Technical Service Bulletin (TSB)
RSU With Additional Sleep Cycles for HV Battery Integrity
Check - Flash: Motor Control Processor A (MCP A) Updates 6A1

REFERENCE:	TSB: 08-079-25 REV. A GROUP: 08 - Electrical	Date:	April 29, 2025	REVISION:	08-079-25
VEHICLES AFFECTED:	2025 (LB) Dodge Charger This bulletin applies to vehicles built on or before **April 03, 2025 (MDH 0403XX)** equipped with a 400V G2500 FR/RR Elec Drive Motors (Sales Code ELD).	MARKET APPLICABILITY:		<input checked="" type="checkbox"/> NA	<input checked="" type="checkbox"/> MEA
				<input checked="" type="checkbox"/> SA	<input checked="" type="checkbox"/> IAP
				<input checked="" type="checkbox"/> EE	<input checked="" type="checkbox"/> CH
CUSTOMER SYMPTOM:	<p>Customers must experience a Malfunction Indicator Lamp (MIL) illumination and the vehicle must exhibit/set the following Diagnostic Trouble Code (DTC):</p> <ul style="list-style-type: none"> • P1626-00 - Park Pawl Motor Stuck. <p>The customer may comment on one or more of the following symptoms:</p> <ul style="list-style-type: none"> • Wrench icon is illuminated on the Instrument Panel Cluster (IPC). • Turtle icon illuminated on the IPC. • Reduced power. • Vehi

Fig. 3
#38 AGSM Fuse Location

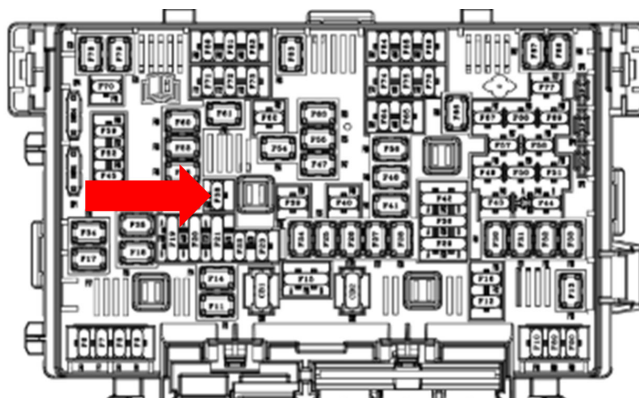
6. Remove the PDC cover, locate and remove the #38 AGSM fuse [Fig. 3](#).**

24. **Install the #38 AGSM fuse [Fig. 3](#) and the PDC cover [Fig. 2](#).
